Access Compliance Report Public Rights-of-Way (Curb Ramps)

Intersection ID: 43083 Main Street: N_KINGS_DR Cross Street: ARMORY_DR Location: E

ADA ID: 218B57627703 Ramp Type: Perp Initial Pass/Fail: Fail Overall Compliance: No Severity Score: 10

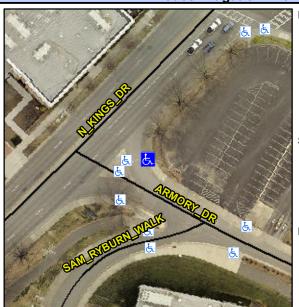
Not Found, R304.5.1, R304.5.3

Field Measurements/Component Compliance					
Compliance Description		Data	Compliance Description		Data
N/A	Ramp Length (in)	84.0	Yes	Ramp Slope (%)	6.1
No	Ramp Width (in)	45.0	No	Ramp XSlope (%)	4.4
N/A	Flare Type LT	N/A	N/A	Flare Type RT	N/A
N/A	Flare Slope LT (%)	N/A	N/A	Flare Slope RT (%)	N/A
N/A	Flare Traversable LT?	N/A	N/A	Flare Traversable RT?	N/A
N/A	Landing Length (in)	N/A	N/A	DWS Provided?	N/A
N/A	Landing Width (in)	N/A	N/A	DWS Contrast?	N/A
N/A	Landing Slope (%)	N/A	N/A	DWS Length (in)	N/A
N/A	Landing X Slope (%)	N/A	N/A	DWS Full Width?	N/A
N/A	Landing Curb? (Y/N)	N/A	N/A	DWS Offset (in)	N/A
N/A	Shared Landing?	N/A			
N/A	Gutter Ponding?	N/A	N/A	Gutter Slope (%)	N/A
N/A	Gutter Lip Ht (in)	1.0	N/A	Gutter X Slope (%)	N/A
N/A	Painted X Walk1?	No	N/A	Painted X Walk2?	N/A
	X Walk 1 Direction	To W		X Walk 2 Direction	N/A
N/A	X Walk 1 Width (in)	N/A	N/A	X Walk 2 Width (in)	N/A
	X Walk 1 Slope (%)	2.3		X Walk 2 Slope (%)	N/A

Remove & Replace Entire Ramp.
